## Architectural Commission Report

**Subject:** **BARNEYS NEW YORK (PL1412574)**  
**9570 Wilshire Boulevard**

Request for approval of a sign accommodation to allow awning signage to exceed one line of text. The Commission will also consider adoption of a Categorical Exemption, pursuant to the California Environmental Quality Act.

1 ENLARGED SIGNAGE  
S&B 8/14/14

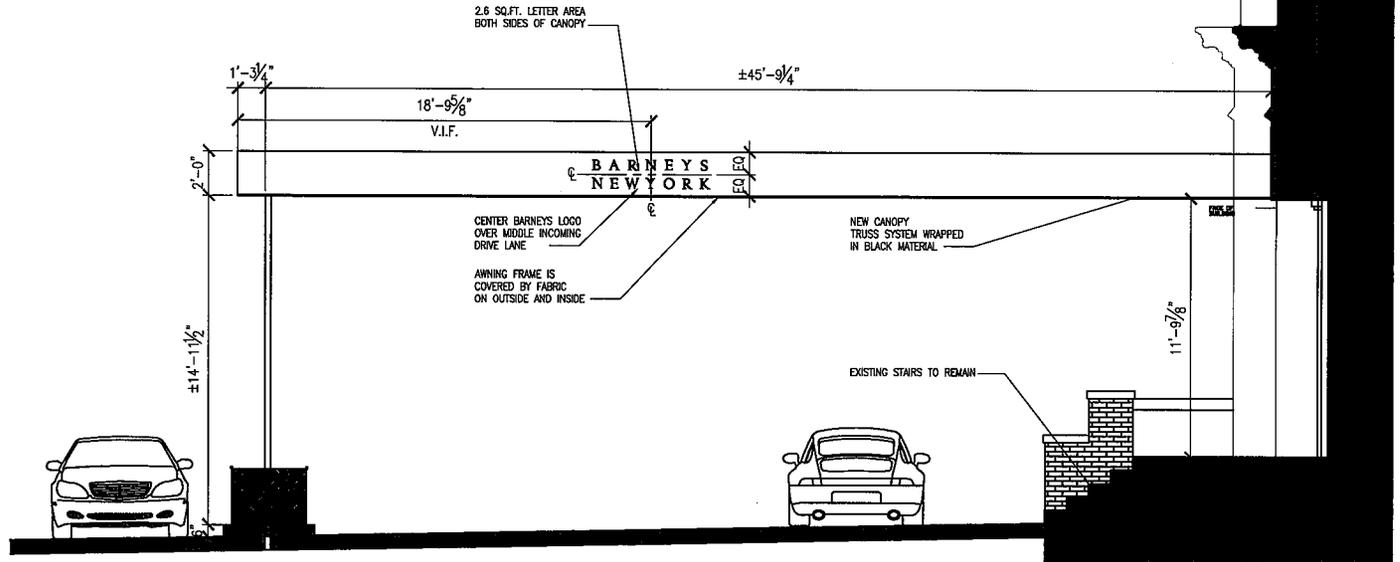
Pursuant to Beverly Hills Municipal Code §10-4-306, the maximum signage on such an element is one line of text with a maximum height of seven inches (7"). However, the Architectural Commission may approve a sign accommodation to allow letters and symbols to be painted or fixed in more than one line provided that the total height does not exceed fourteen inches (14").

As the current signage is proposed at a height of sixteen inches (16"), a condition of approval has been included in the draft approval resolution (Attachment C) that indicates such signage must be reduced to a total height of fourteen inches (14").

1. Each business identification sign located on the drive aisle canopy shall be reduced to a total maximum height of fourteen inches (14”), inclusive of each line of text and the spacing between.
